H11507

## DESCRIPTIVE REPORT

General Locality ..... Ernest Sound and Eastern Passage

## **Revisions Compiled During Office Processing and Certification**

Figure 2: Junction between H11507, H11406 and H11508

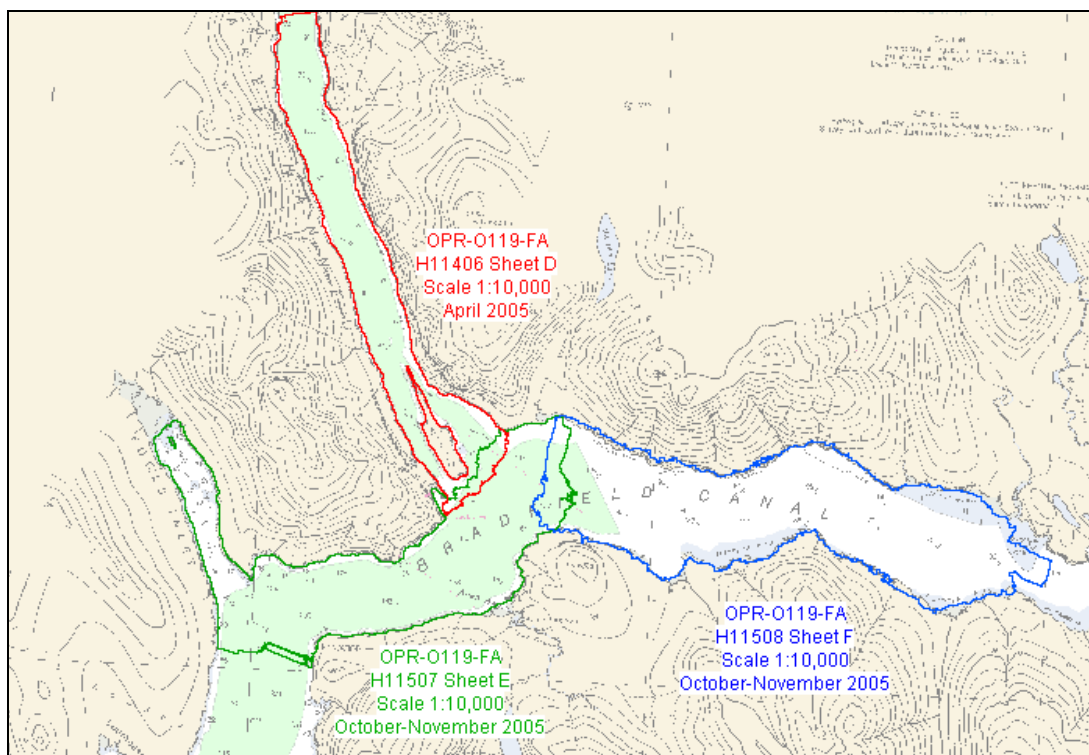
Survey H11507 junctions with H11406 (Sheet D) and H11508 (Sheet F) of the same project. The area of overlap between the sheets was approximately 200 meters wide. Data were reviewed in CARIS Subset Editor and depths were found to be consistent among the three surveys, meeting the requirements as stated in the *NOS Hydrographic Surveys Specifications and Deliverables*.<sup>4</sup> The sheet limits and area of overlap for Sheets E, D, and F are shown in Figure 2.

<sup>4</sup> Concur with clarification. There were differences up to 10m between H11507 outer beams and the edge of H11406. The outer beams of H11507 were cleaned during the Survey Acceptance Review and the junction now agrees within 1m.

**Figure 3: Charted (17385) soundings near the north end of Fools Inlet, east shore, and corresponding least depths found by MBES.**

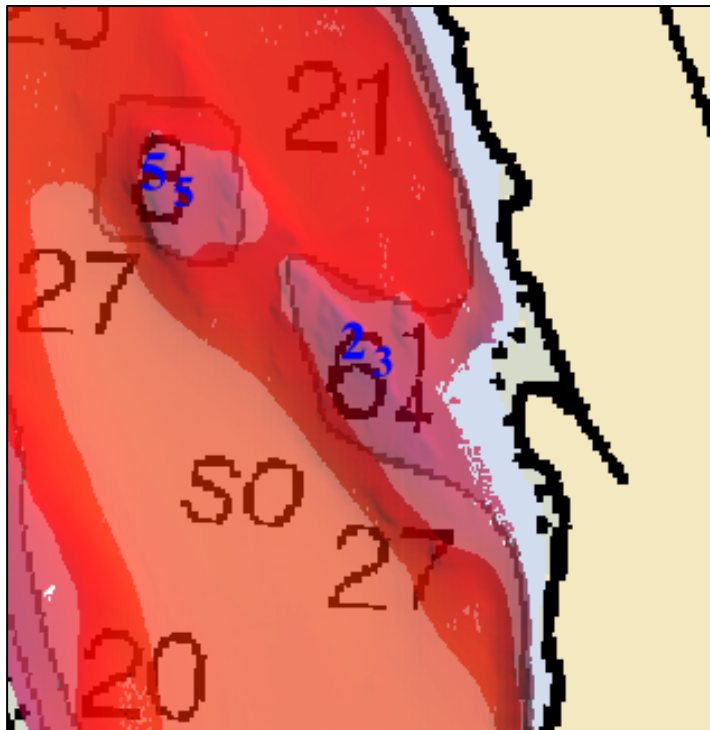
A 5.8 fathom sounding was found by MBES at a charted 8 fathom sounding in the north end of Fools Inlet (see figure 3).<sup>15</sup>

A 2.49 fathom sounding was found by MBES at a charted 6 ¼ fathom sounding on the east shore of Fools Inlet (see figure 3).<sup>16</sup>

<sup>15</sup> See DTON section of attached Features Report.

<sup>16</sup> See DTON section of attached Features Report.

**Figure 4: Southeast shore Fools Inlet, 7.98 fathom sounding found by MBES between a charted (17385) 17 fathom and 9 fathom sounding.**

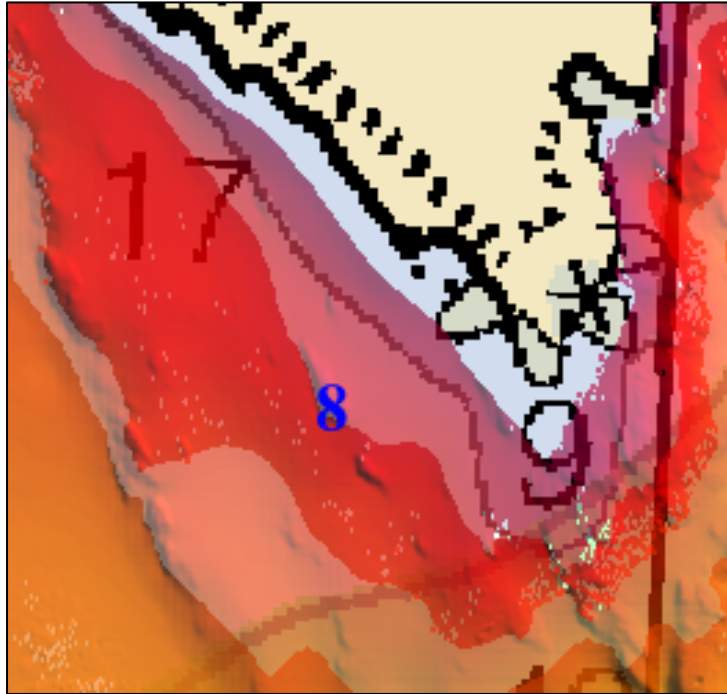
A 7.98 fathom sounding was found by MBES between a charted 17 fathom and 8 fathom sounding on the south east shore of Fools Inlet (see figure 4).<sup>17</sup>

<sup>17</sup> See DTON section of attached Features Report.

*Figure 2.2.1 5.88 FM sounding*

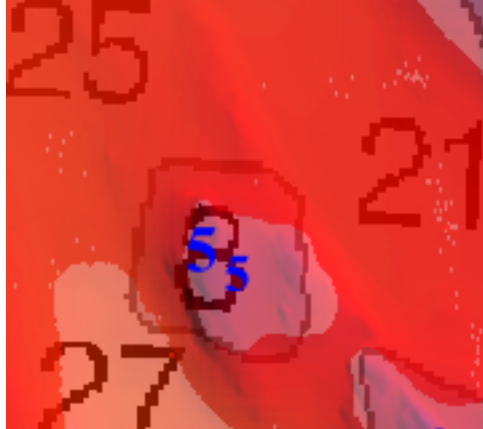
5.88 ftm sounding found on Chd (17385) 8 ftm shoal.

The Hydrographer recommends changing the charted 8 fathoms to the measured value of 5.88 fathoms

Shoal sounding reported as DTON and has been applied to applicable charts. No further charting action required.

*Figure 2.3.1 2.49 FM sounding*

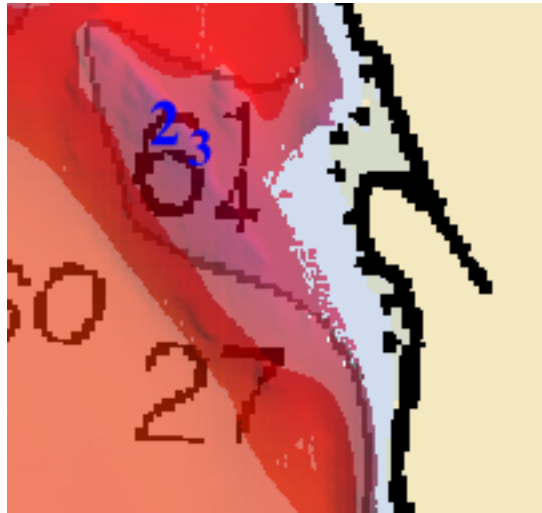
2.49 ftm sounding found on Chd (17385) 6 1/4 ftm shoal.

The Hydrographer recommends changing the charted 6 1/4 fathoms to the measured value of 2.49 fathoms

Shoal sounding reported as DTON and has been applied to applicable charts. No further charting action required.

*Figure 2.4.1 7.98 FM sounding*

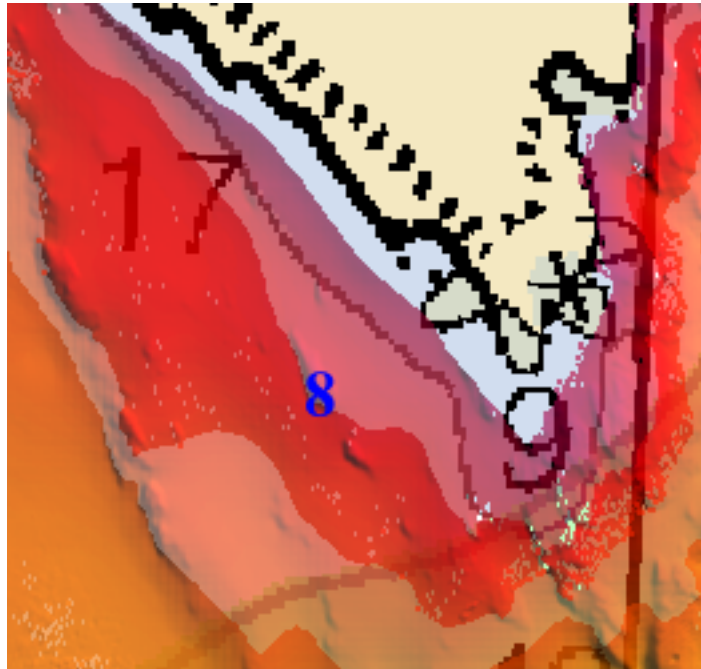
7.98 ftm sounding found between Chd (17385) 17 and 9 ftm sounding

The Hydrographer recommends adding the measured 8 fathom sounding in between the charted 17 and 9 fathom soundings

Shoal sounding reported as DTON and has been applied to applicable charts. No further charting action required.
